**STATE SIGNIFICANT DEVELOPMENT  
ASSESSMENT REPORT:**  
***Site 53, 2 Figtree Drive, Sydney Olympic  
Park***

**SSD 7033**

Environmental Assessment Report  
Section 89H of the *Environmental Planning and  
Assessment Act 1979*

**Figure 6:** Exceedance of building height limit – eastern elevation (Source: Applicant's EIS).

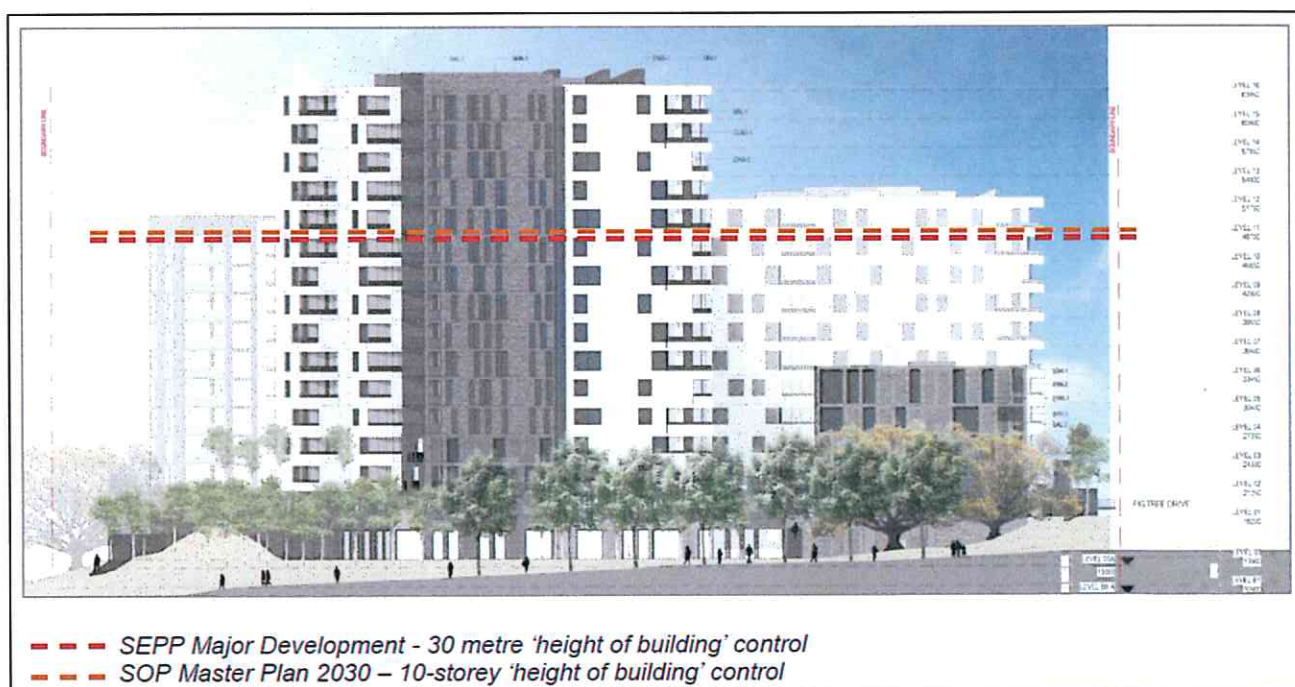
Three of the four proposed buildings exceed the 30 m maximum building height development standard in the SSP SEPP. Two of the four proposed buildings exceed the similar 10-storey building height control in the *Master Plan*. This is set out in detail in **Table 4** and illustrated in **Figures 6 and 7**.

**Figure 12:** Parapet Treatment of eastern building (Source: Applicant's EIS).

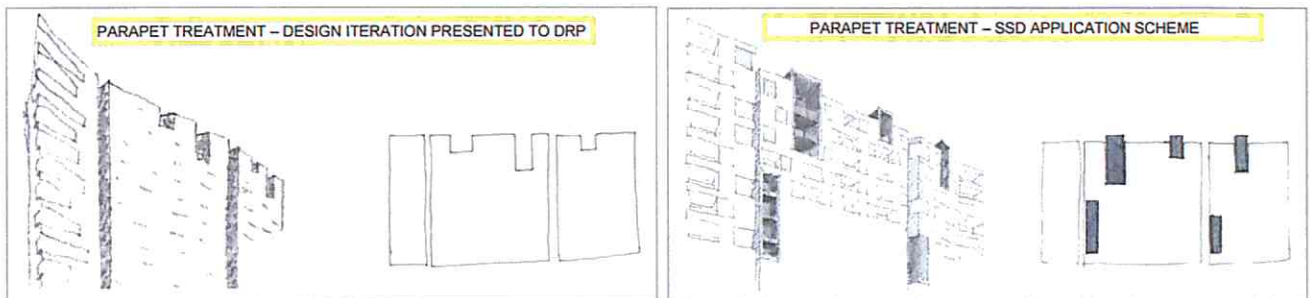
principle, they raised some concerns in respect of the lack of articulation to the 15-storey eastern building and the materiality of its south-east frontage. No other changes were requested by the DRP and SOPA in respect of the other buildings.

The design competition scheme incorporated a castellated parapet to the eastern building. Prior to the lodgement of the development application, the castellated parapet was infilled with pop-out elements (refer to **Figure 12**).

During the exhibition of the proposal, SOPA expressed its continued concerns relating to the parapet treatment of the tallest building (eastern building) and that it did not support the current scheme. SOPA requested the castellated parapet be reinstated to minimise the bulk of the building and its perception as an additional storey.

The Applicant contends in the RtS, that the pop-out elements introduce variation in the materiality and finishing which would sufficiently articulate the building.

The Department has therefore recommended a condition requiring the Applicant to update the architectural plans to reinstate the castellated parapet to the eastern building and remove the pop-out elements which is consistent with SOPA's recommendation. The plans would be required to be submitted to the Secretary for approval prior to the issue of a Construction Certificate.

**Figure 18:** Figtree Forecourt (Source: Applicant's EIS).

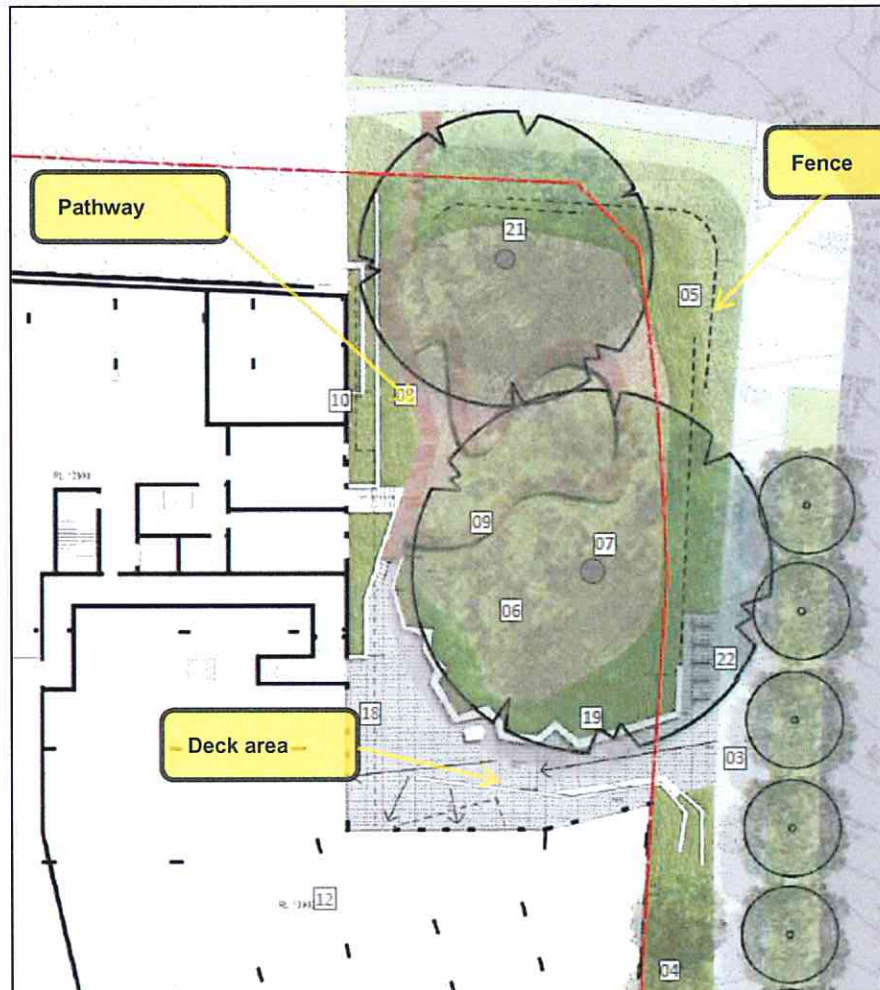
- building lobbies should have direct access from the public streets;
- the design of the Linear Park entry is restrictive of future design options of Linear Park; and
- the Figtree Forecourt should incorporate a larger deck, a more direct pathway and the removal of the proposed fence (see **Figure 17**).

The Department also shares SOPA's concern that the Figtree Forecourt appears to lack clear legibility and accessibility due to the indirect pathways and narrow stairs from Australia Avenue. Further, the fence appears to enclose this area when it should present as an open space (see **Figure 17**).

Accordingly, the Department has recommended a condition requiring the Applicant to prepare detailed landscape plans in consultation with SOPA. The landscape plans will be required to:

- allow for flexibility of the Linear Park entry steps to consider the future design of Linear Park;
- remove the perimeter fence to the Figtree Forecourt; and
- give further consideration to the recommendations detailed in the Arborist Report, submitted with the EIS, in relation to the potential extension of the forecourt deck and reconfiguration of the pedestrian pathway.

**Figure 20:** Section plan illustrating the proposed location of the electrical substation on Figtree Drive (Source: Applicant's EIS).

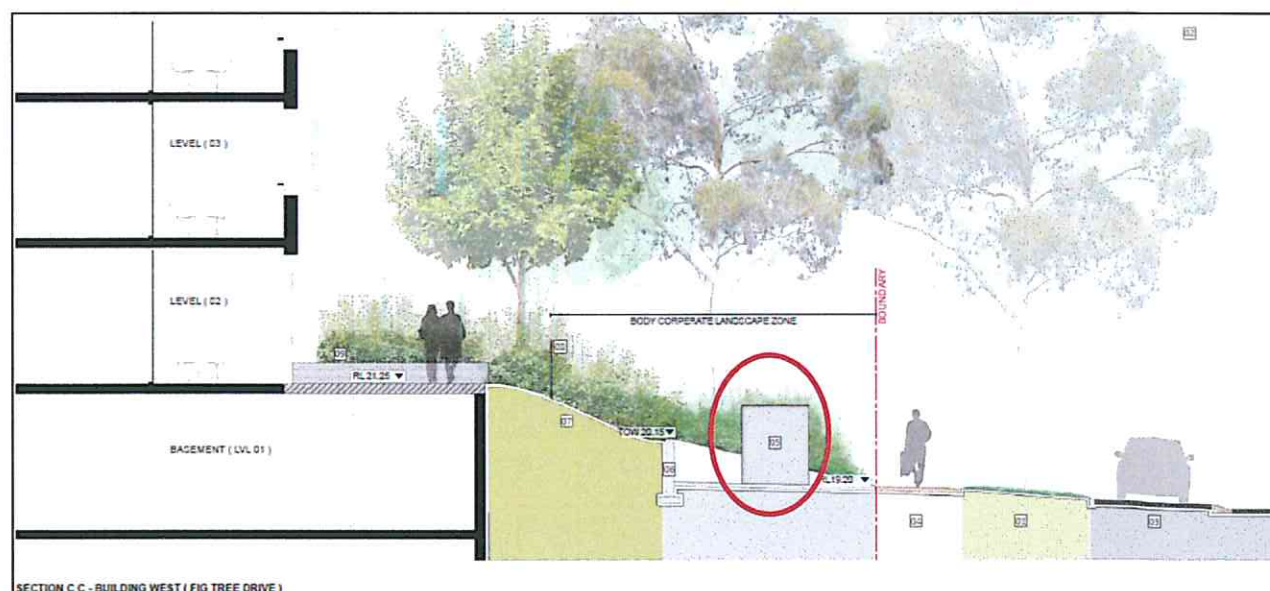
The proposal includes a freestanding electrical substation on Figtree Drive (see **Figure 19**). The Department and SOPA have raised concerns regarding its prominent location and high visibility on Figtree Drive.

The Department requested the Applicant explore further options for its location and the possibility of integrating the substation into the building.

The Department acknowledges the Applicant has attempted to integrate the substation into the landscaped setback area to minimise its visual presence. Notwithstanding, the Department considers the visual treatment of the substation requires further consideration and further options should be presented for review. As such, a condition requiring the Applicant prepare final landscape plans, detailing the location and treatment of the substation, be prepared in consultation with SOPA and submitted to the Secretary for approval prior to the issue of a construction certificate.

**Figure 21:** Distance between living rooms and balconies. Note the distance between the south and west buildings (Source: Applicant's EIS).

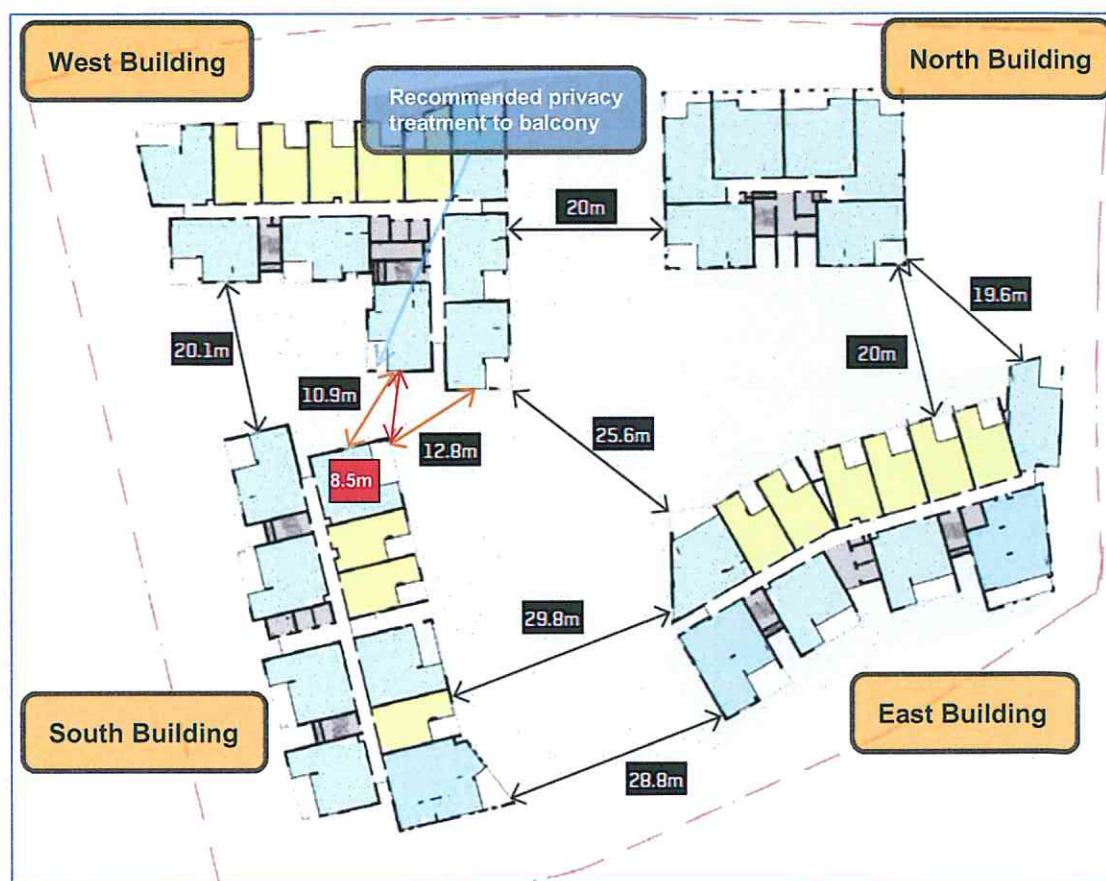
The rooms at which the non-compliance occurs is to balconies and living room windows. In order to maintain a reasonable level of privacy, privacy screens are provided to the balconies in the south building and smaller and staggered window openings are provided to both buildings. The separation distances between these window openings and the balconies are 10.9 m (-1.1 m non-compliance) and 12.8 m (see **Figure 21**).

The Department notes that reasonable measures have been provided to address the reduced separation distance between the buildings. However, it is also recommended that privacy screens be provided to the southern wall of the west building balconies (see **Figure 21**) to minimise any potential visual privacy impacts between the buildings.

**Figure 24:** Proposed balconies that do not comply with the minimum depth requirement (Source: Applicant's EIS).

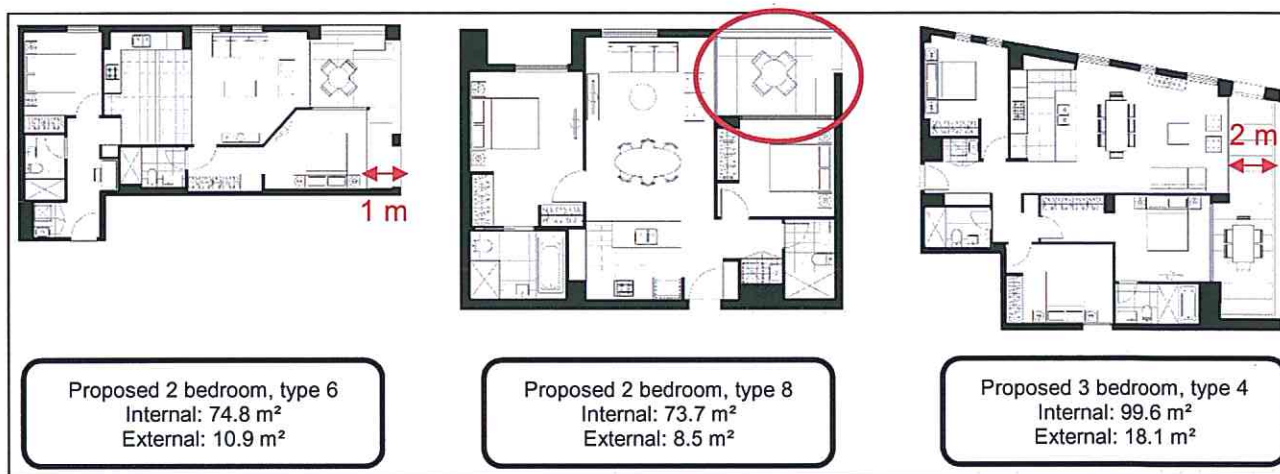
- 2 bedroom apartment - Type 6: complies with the minimum area requirements, although the balcony has a depth of 1 m to a portion of the POS due to its irregular shape (see **Figure 24**);
- 2 bedroom apartment - Type 8: provides a POS area of 8.5 m<sup>2</sup>, however the balcony complies with the minimum depth requirement;
- 3 Bedroom – Type 4: complies with the minimum area requirement however, the balcony has a depth of 2 m to a portion of the POS due to its irregular shape (see **Figure 24**); and
- Ground floor apartments: due to the significant level changes to the southern portion of the site, three of the 27 ground floor apartments provide a POS area of 11.3 m<sup>2</sup> to 12.1 m<sup>2</sup> and a minimum depth of less than 3 m.

Notwithstanding, all POS is located adjacent to living spaces and have been designed to be integrated within the building architecture. The architectural plans also illustrate that the balconies can accommodate a table and chairs.
